# Recall Bulletin

## PRODUCT SAFETY RECALL

**SUBJECT:** Shift Lever Indicator May Not Display Correct Gear

**MODELS:** 2008-2010 Chevrolet Malibu  
2008-2010 Pontiac G6  
2007-2010 Saturn AURA  
Equipped with 4-Speed Automatic Transmission (ME7/MN5)

2269489

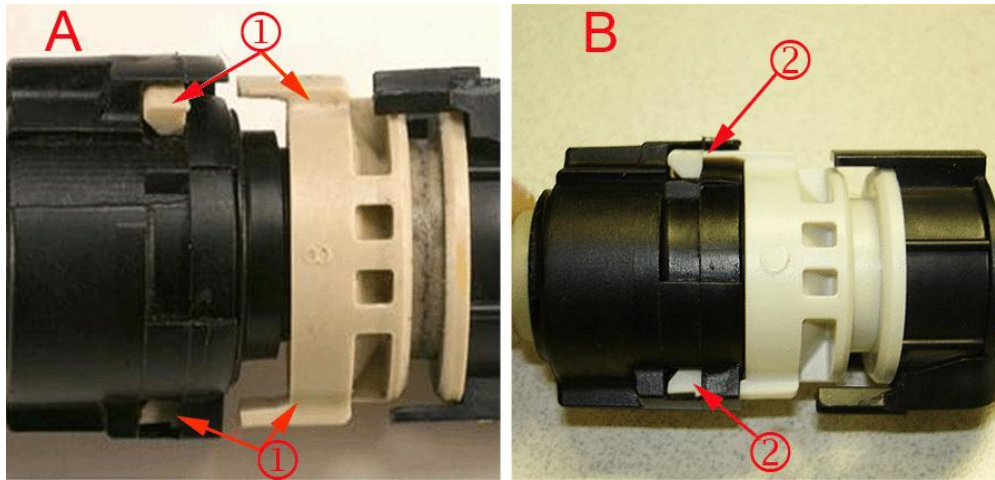
- (1) Shift Cable Locking Tabs
- (2) Shift Cable Adjuster Locking Clip

1. Open the hood and locate the transmission shift cable.

2269486

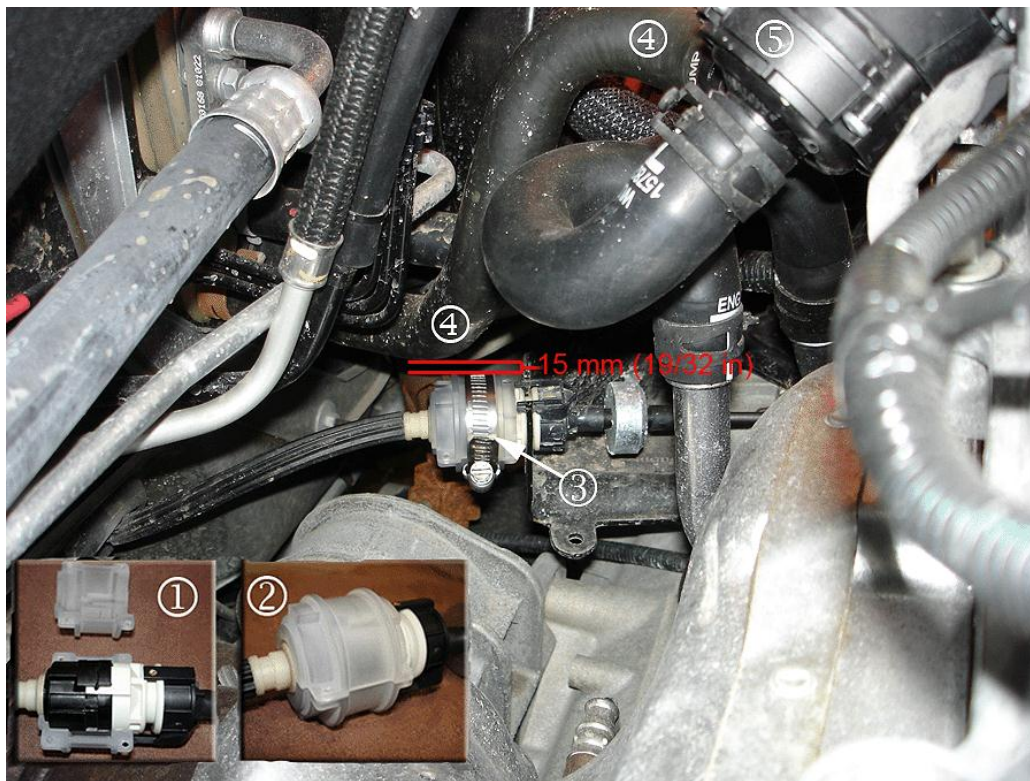
2. Determine if the transmission shift cable locking tabs are fractured and separated.

- If the transmission shift cable locking tabs (1) are fractured and separated (A), remove the transmission shift cable and replace it with a new one. Refer to *Floor Shift Control Cable Replacement or Range Selector Lever Cable Replacement* in SI. **Also install a transmission shift cable kit with the new shift cable.**
- If the transmission shift cable locking tabs (2) are NOT fractured and separated (B), install the transmission shift cable kit. Proceed to Step 3.
